Bid Addendum No. 1
February 9, 2023

*Subject: Village of Lake Barrington
Hillview Drive and Hillside Drive Improvements
Section No.: 23-00000-00-PV
February 13, 2023 Letting*

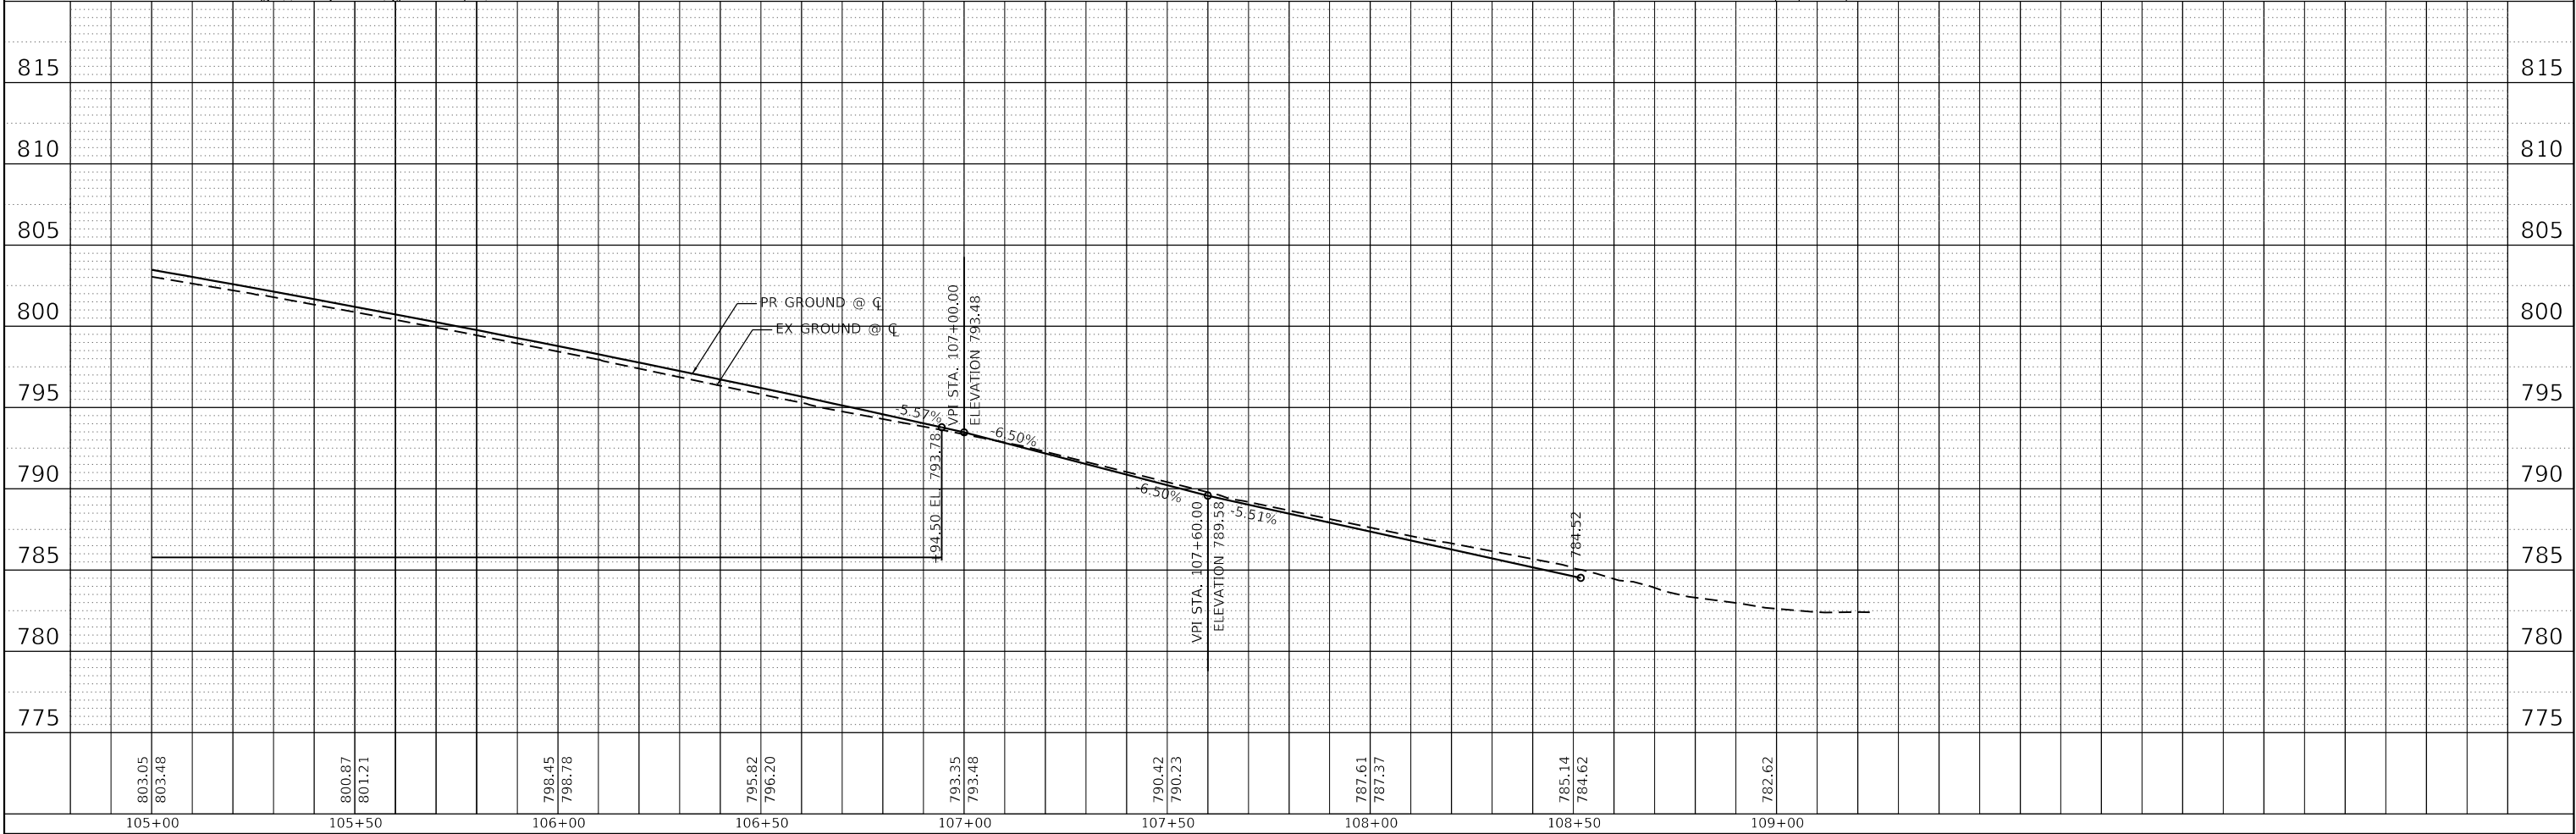
The configuration of the lift station area at the north end of Hillview Drive has been revised to fit within the existing easement area. COMBINATION CONCRETE CURB AND GUTTER, TYPE B6.12 and associated parkway restoration items have been adjusted accordingly.

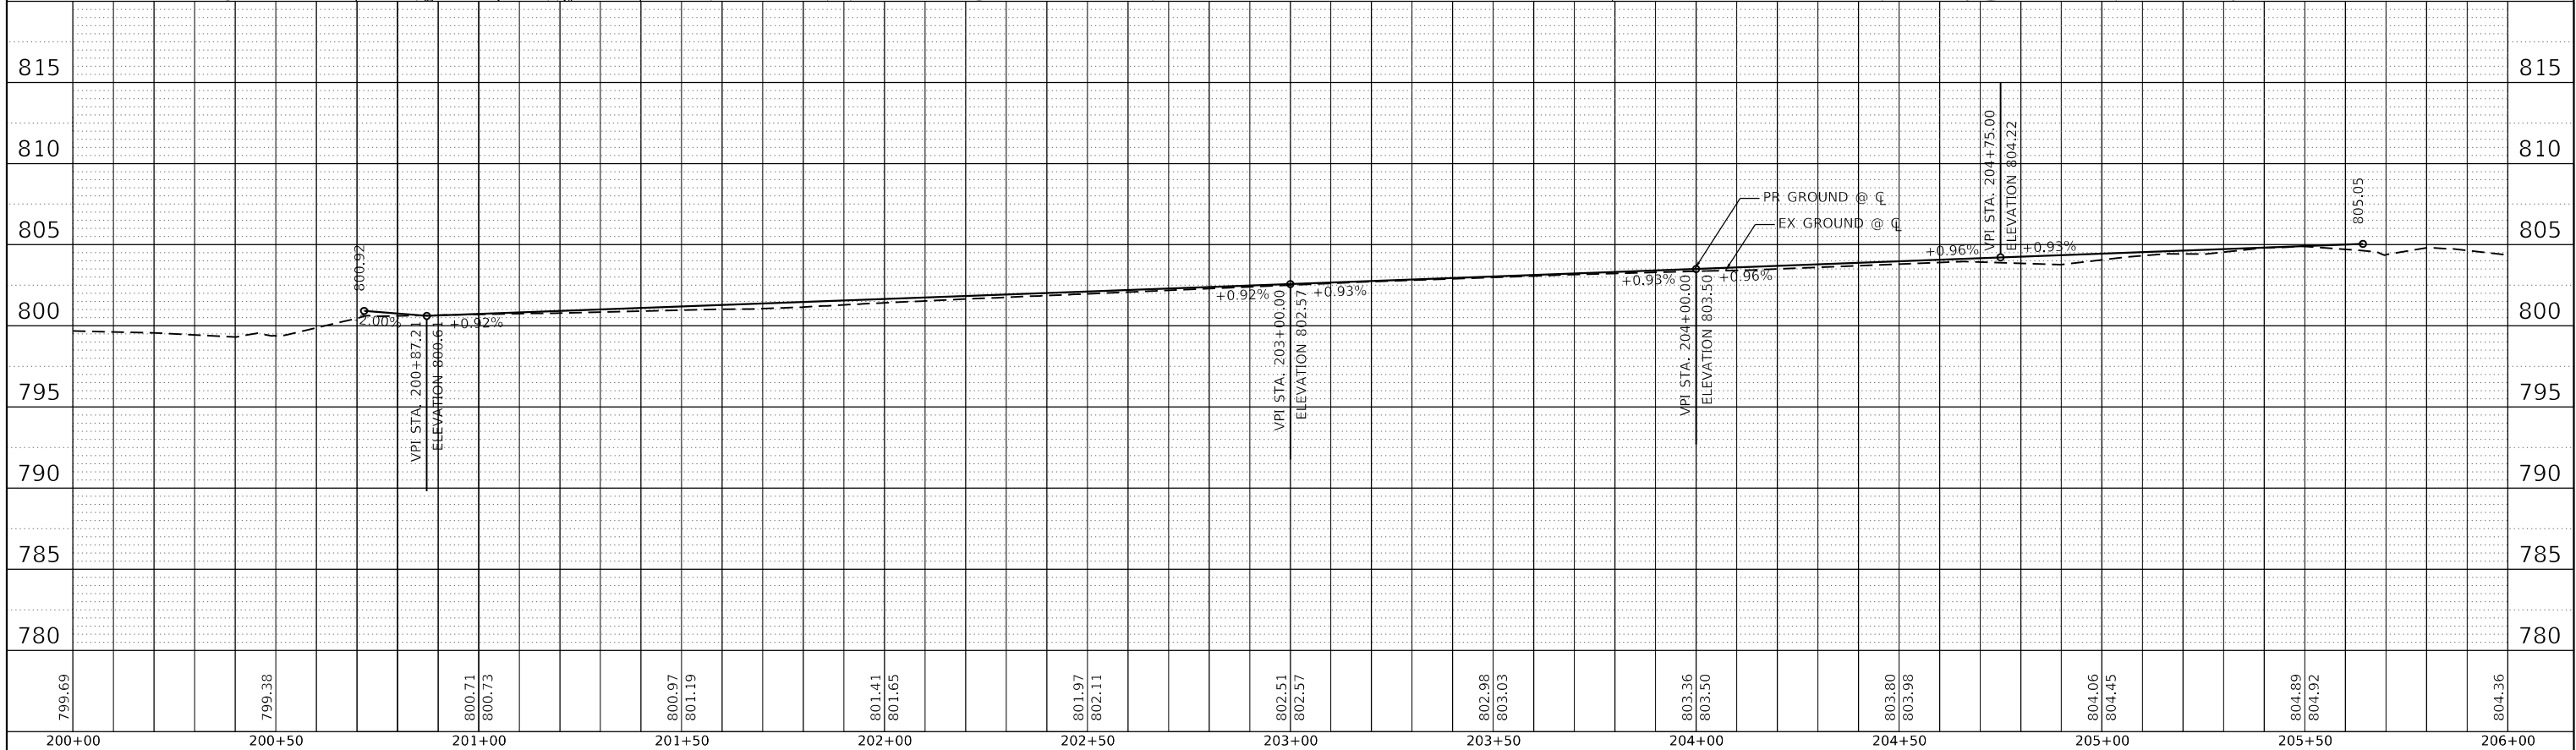
The existing fire hydrant at approximately station 203+02 on Hillside Drive has been changed from FIRE HYDRANTS TO BE ADJUSTED to FIRE HYDRANTS TO BE RELOCATED. The proposed fire hydrant location with elevation data is provided.

TYPICAL MAILBOX AND POST DETAIL

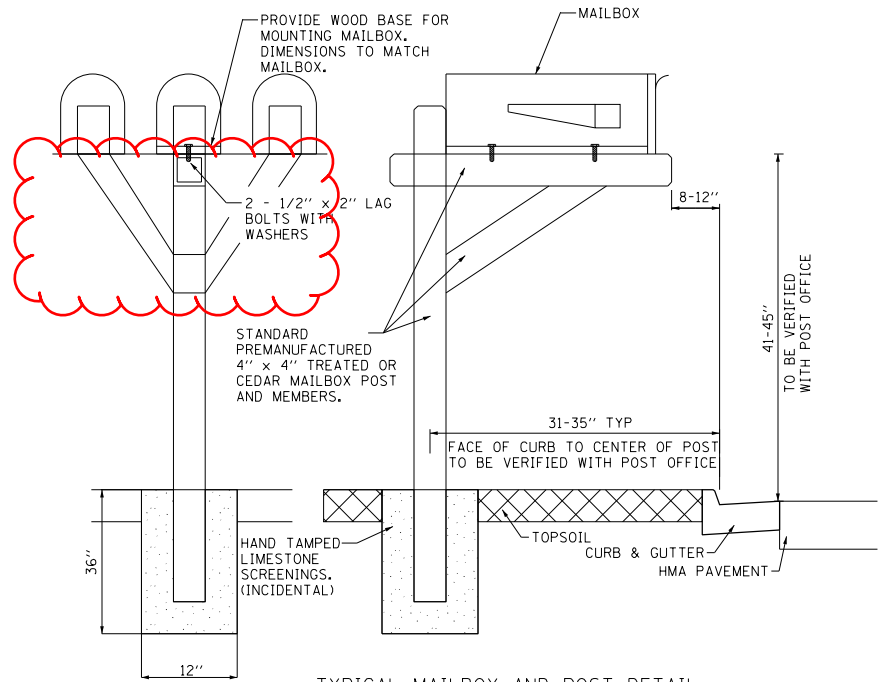
The construction detail for Typical Mailbox and Post Detail has been modified to include additional wood bracing. Additionally, a construction detail has been added for Typical Concrete Bollards.
